PRODUCT BULLETIN

Bulletin No: PB528

Change to Solder Feed Drives for FU-500 and HU-200

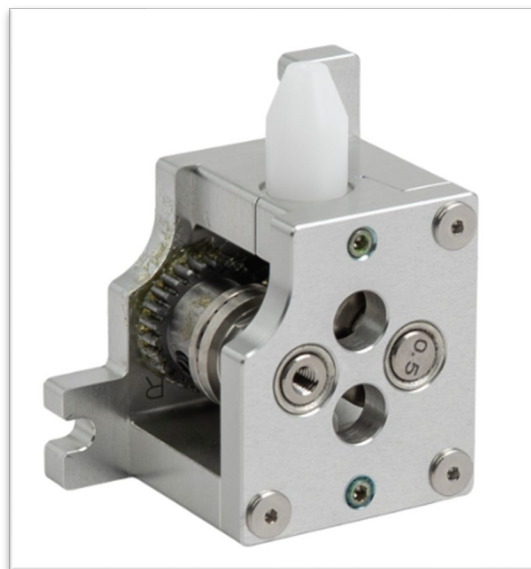
When the FU-500 and HU-200 were introduced (Ref PB416 and PB424), the Solder Feed Drive used to feed the solder was designed to grip the solder by perforating the wire to the flux core. Over time, the blades dull, and when the solder feed is jammed, solder and flux clog the cutting wheel. Due to the design of this part, it was not easy to service and typically required full replacement.

As part of our continual product improvement efforts, the design of the Solder Feed Drive has been changed to make it a serviceable part that can be disassembled for cleaning and allows for individual replacement of the drive wheel, follower wheel, and PTFE guides.

This change will begin to appear, starting with the Solder Feed Drive for 0.3mm diameter solder, as we cycle through our inventory this year. Part numbers for the old design will transition to new part numbers, and once the supply is depleted, the old part numbers will be discontinued.

Old Design: BX1000, BX1001, BX1002, BX1003, BX1004, BX1005, BX1006

New Design: BX1076, BX1077, BX1078, BX1079, BX1080, BX1081, BX1082

Unchanged. New and Old design are interchangeable.
